**COUNCIL ACTION FORM**

**REQUEST: MAJOR SITE DEVELOPMENT PLAN (LANDSCAPE PLAN) FOR VILLAGE PARK SUBDIVISION “OUTLOT A” (3201 UNIVERSITY BOULEVARD) AND “OUTLOT D” (2036 COTTONWOOD ROAD)**

# Attachment B: Landscaping Plan for Outlots A & D, Village Park Subdivision

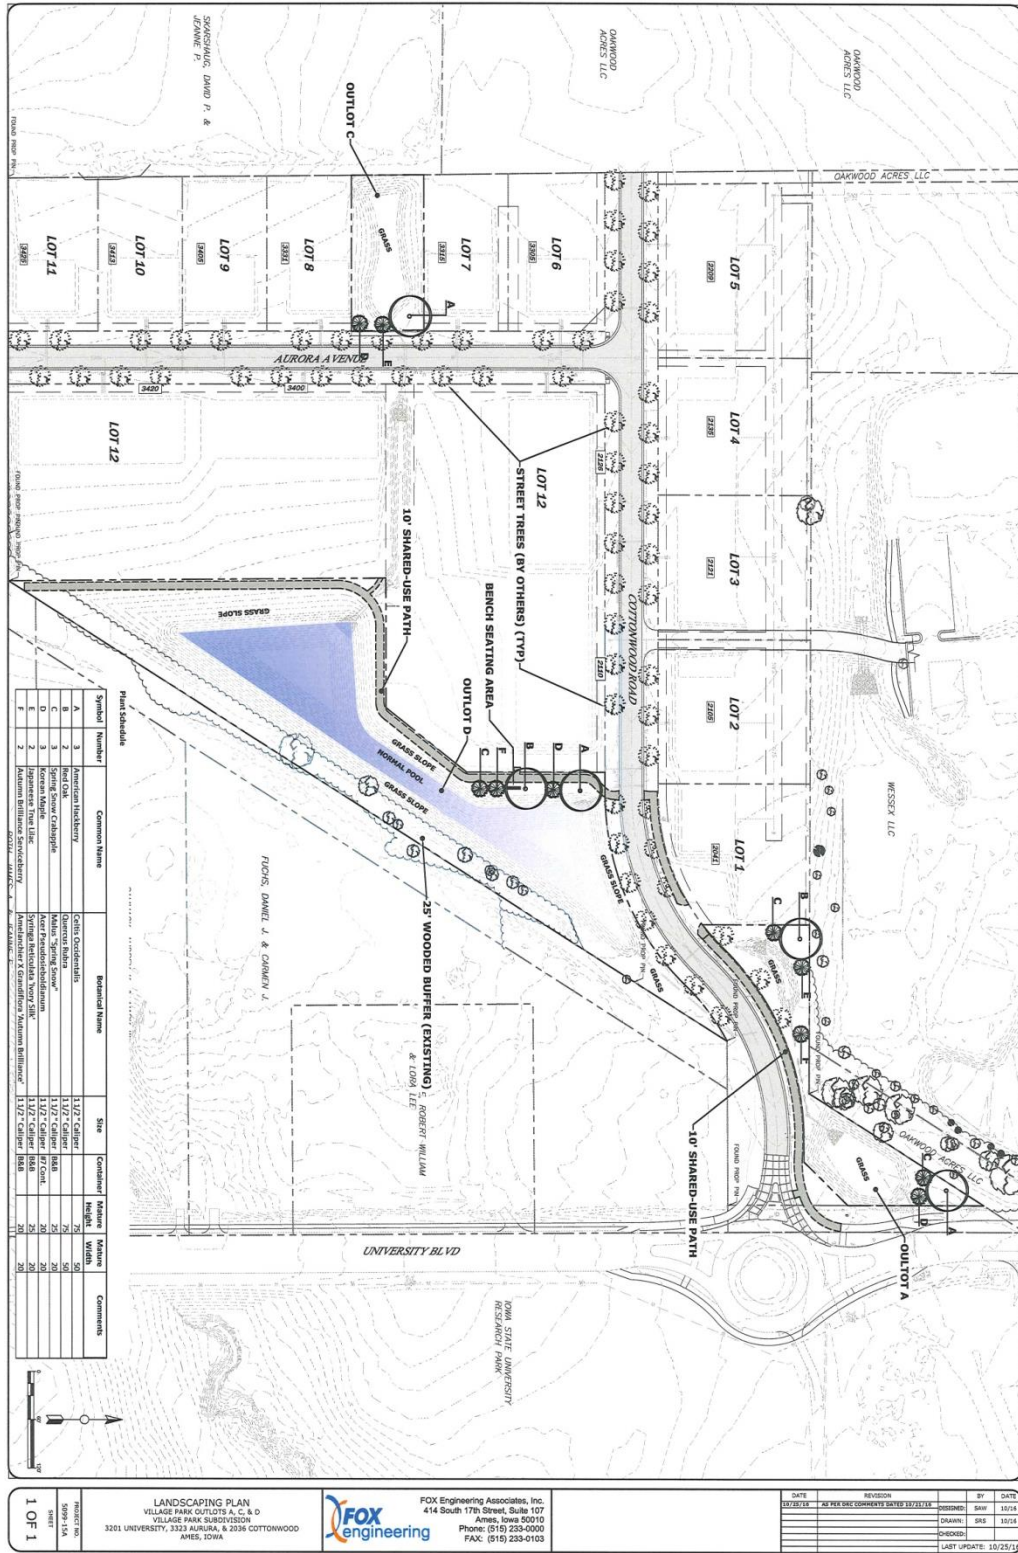
Outlot D includes an area for the shared use path (10 feet wide) next to the west boundary of Outlot D, and a small area for two trees, three shrubs and a bench. This path connects to the shared use path that will be constructed within the right-of-way on the north side of Cottonwood Drive. The proposed location of the shared use path to the south is approximately two feet from the west boundary of the outlot. The path is

generally within 10 to three feet from the edge of the slope of the stormwater pond. The interface to the west of the path will be with a parking lot of the RH apartment development. The RH apartments will likely have a 5-foot planter with an L3 screen of a fence or high shrubs.

Staff has concerns about the design of the path up against the RH property line due to the interface with the buffering. **The path was originally intended to be on the east side of the outlot, but during the Master Plan and subdivision review residents living east of the site asked that it be placed on the west side.** Staff believes having a greater separation from the RH would better meet the design principles for open well landscaped areas within suburban zoning. The developer is concerned that adjusting the path location further from the property line would affect their stormwater detention design and impact the overall project design

In addition, the Landscape Plan shows the shared-use path terminating short of the southern boundary of Village Park Subdivision. An easement is needed on Lot 12 to provide for the extension of the shared-use path to the southern boundary of Lot 12, and eventually continue outside the Ames corporate limits in rural Story County. This needs to be added as a condition of approval of the Major Site Development Plan (Landscape Plan) for Outlot D, at 2036 Cottonwood Road.

Outlot A abuts the shared use path in the right-of-way for Cottonwood Road. The developer is proposing two groupings of one tree and two shrubs along the northwest perimeter of Outlot A, and a single shrub between the two groupings. Landscaping of the two outlots with trees, shrubs and amenities for the residents of Village Park Subdivision is minimal, beyond the shared use path that is routed through Outlot D. Staff believes that adding two large street trees at the southwest intersection with University Boulevard would tie the site together better than the two open areas that are now proposed.

- A. Provide two large overstory street trees (e.g. red oaks) within the southwest corner of the Cottonwood/University right-of-way.
- B. No fencing of the stormwater detention pond along the shared use path.

**Staff has included a third recommended condition of approval, following the action by the Planning and Zoning Commission. The third condition (C) addresses the termination of the path at the south boundary of the outlot. As currently shown, it ends without reaching an abutting property line. To ensure that the path can continue southward, the condition states that the path must end at an easement that allows for future extension.** Due to the “point” of the triangle lot line configuration of the outlot, the continuation of the path must go through an adjoining property, likely Lot 12 of the subdivision where the RH apartments will be built. Staff will include a condition for the minor site development plan of the Lot 12 apartments that an easement and graded area be provided through the lot to allow extension of the path south to the abutting Burgason property. As part of the outlot approval condition, an easement has to allow for the opportunity for the extension to occur on Roth property as well. This allows for two options to extend the path in the future.

- C. Extend the path to the south end of the Outlot D and terminate the trail into an easement area that allows the path to be extended to the southern boundary of Village Park Subdivision.
